SD428 MWWTP Oxygen Plant Rehabilitation

Pre-Bid Update

September 19, 2024

Addendum No. 1

O2 Main Air Compressor Motor Vibration Monitoring System

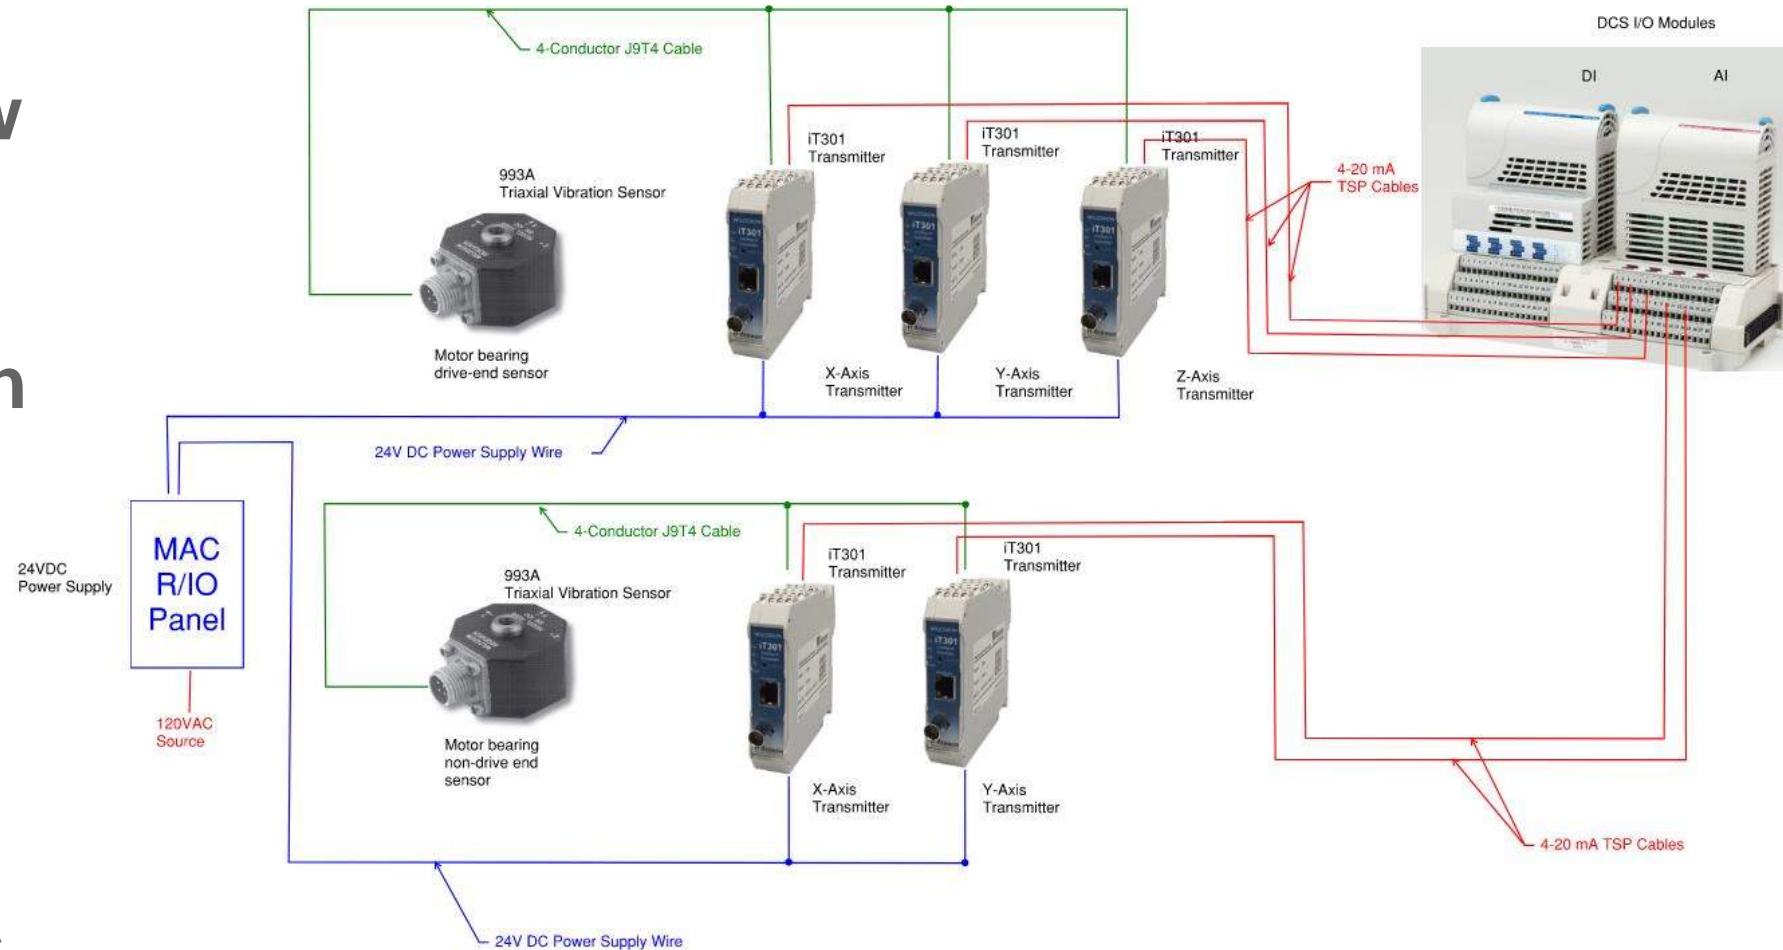
Addenda 1 – MAC Vibration Instrumentation

- Drawings – Updated to show vibration instrumentation consistently with specifications
- MAC - Motor Replacement 22 05 00 - Modified to include vibration probes and transmitters for the motor.

Addendum 2 - New LOX Tank Valves/Piping

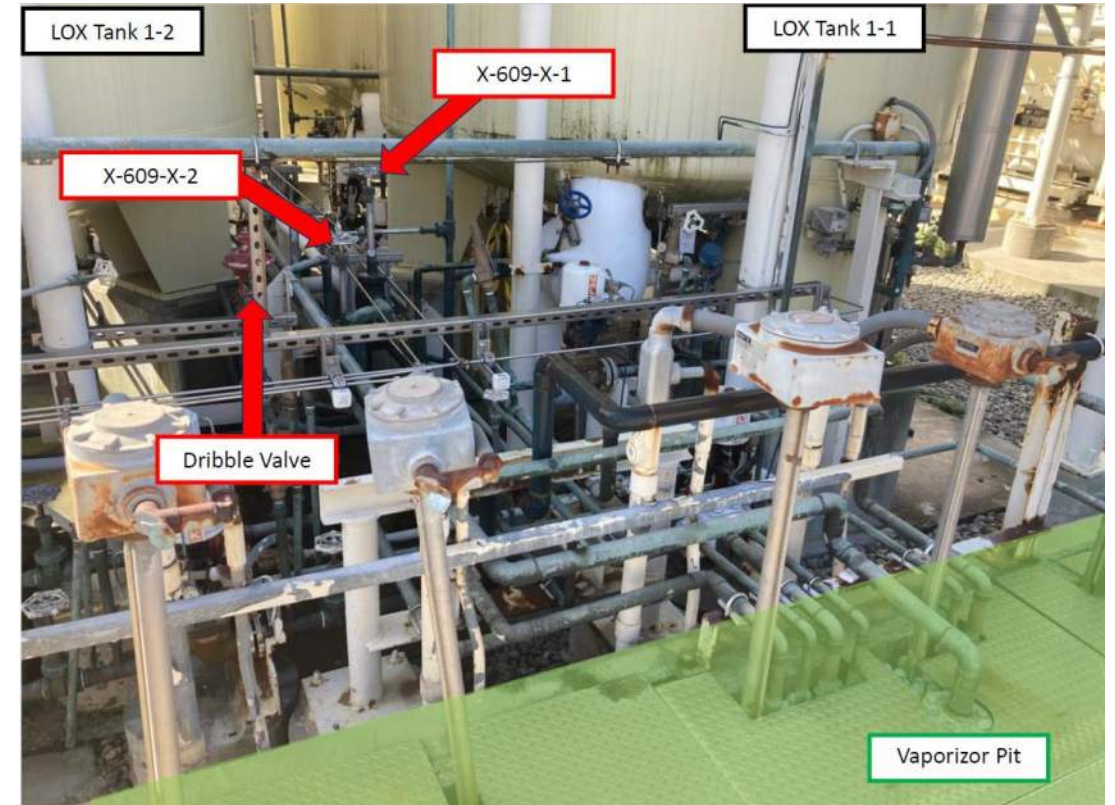
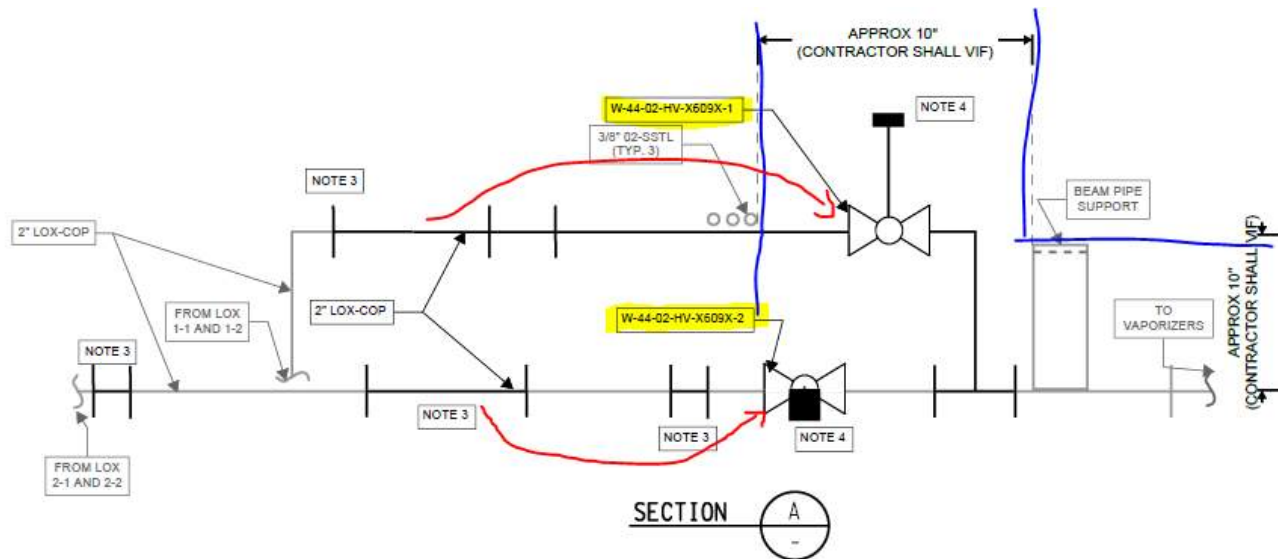
- LOX Tank withdrawal Valve replaced to improve operator access
 - New valves required
 - Modifications to existing copper pipe will be required

- **Specification 05 05 24 Shop and Field Welding and Brazing**
 - Specifications for welding/brazing existing copper pipe
- **Specification 40 05 23a Control Valve Purchase Specifications**
 - New valves added to purchase spec
- **46 31 58 Cleaning for Oxygen and Ozone Service**
 - Requirements will apply to modified pipe sections
